## STAFF REPORT 4/6/2022

**SUBJECT:** Tripoli Mixed-Use Project (Continuance requested to April 20, 2022)

**SPECIFICS:** Change of Zone (CZ) 22-01, Conditional Use Permit (CUP) 351, Architectural Review (AR) 22-04 to amend the Official Zoning Map by adding the PUD (Planned Unit Development) Overlay Zone on 2.8 acres of vacant C-G (General Commercial) zoned property for a mixed-use development consisting of 108 apartment units and 2 retail units. The site is located at the northeast corner of Cesar Chavez Street and Bagdad Avenue (APN# 778-081-003 and -001) Applicant: Chelsea Investment Corporation

**Figure 2: Site Plan**

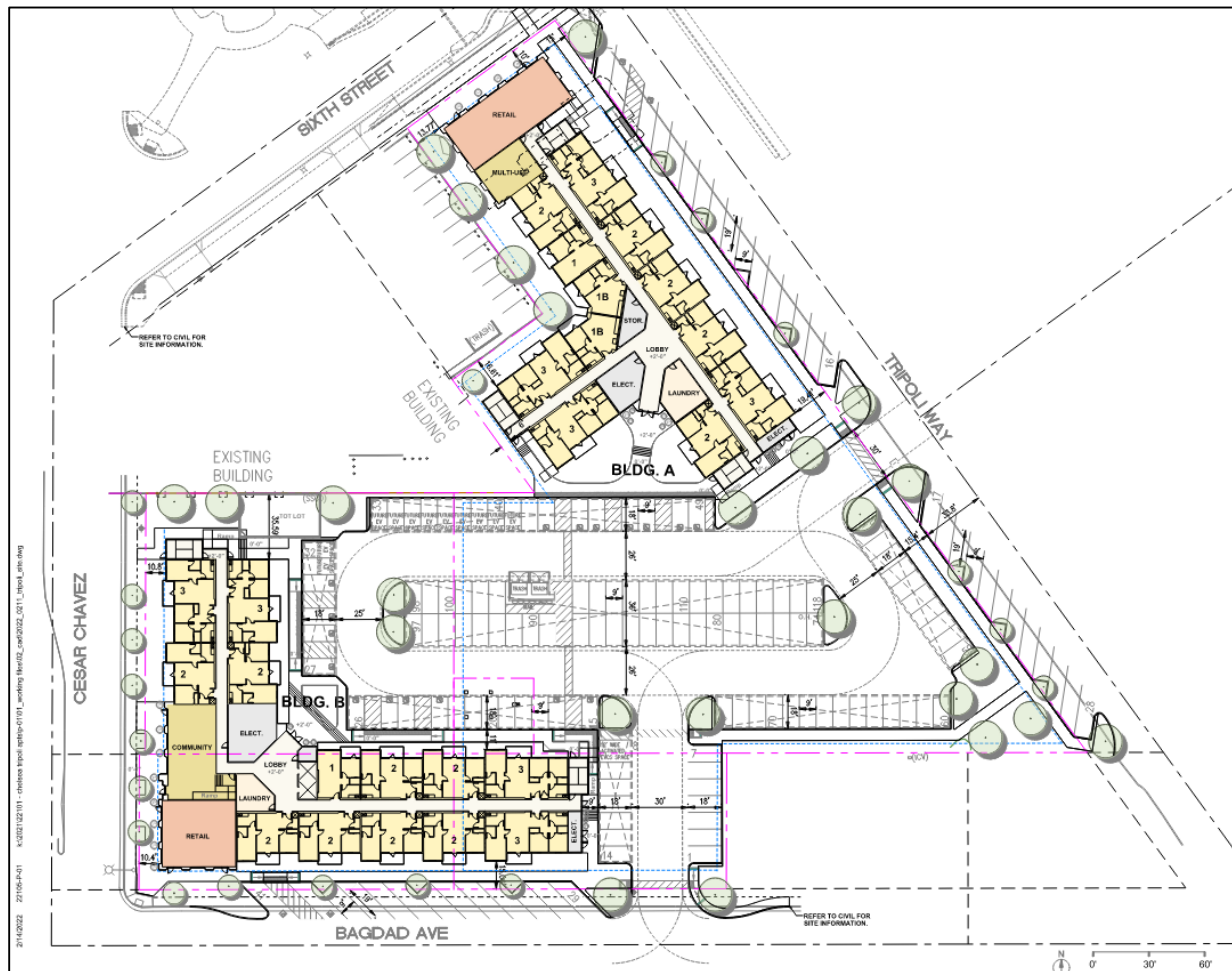
A 652 sq. ft. multi-purpose building and laundry room is proposed on the first floor. The main entrance and lobby is accessed from the parking lot, in addition to 3 other access points. Access above the first floor is by three proposed staircases and no elevator is proposed. Staff has requested that space between the west building elevation and property line be configured to improve safety and opportunity for usable common area for residents and customers of the retail space.

Ground floor retail for Building A and B would not include improvements such as bathrooms, fire sprinklers, or grease traps. The Pueblo Viejo Draft Standards require 15 foot high ceiling for ground floor retail to accommodate modern commercial and retail activities. The applicant has stated that the retail ceiling is 12 feet in height.

A 218 sq. ft. fenced tot lot is proposed near the project parking lot with playground equipment for children. No details of the playground equipment were submitted for the Architectural Review, but will be reviewed during building permit plan check. The project does not provide a significant amount of common outdoor open space for the project, but does contribute to an attractive and high quality streetscape as recommended in the Pueblo Viejo Revitalization Plan.

The parking serving the site is provided with one large on-site parking area consisting of 118 parking spaces and is accessed by driveways from Bagdad Avenue and Tripoli Way. Parking based on 120,873 sq. ft. of gross floor area, would require 362 spaces in the Pueblo Viejo Revitalization Plan. The applicant proposes 118 onsite parking spaces and 41 on-street parking spaces. The Pueblo Viejo Revitalization Plan draft development standards allow for on street parking to be counted toward required parking if within 500 feet of the main entrance of the development. Senate Bill 35 allows affordable housing development within ½ mile of public transit to be exempted from parking standards. With the application of density bonus law, only 61 parking spaces would be required or a surplus of 97 parking spaces. Staff is supportive of allowing the development to utilize on-street parking to count towards satisfying parking requirements,
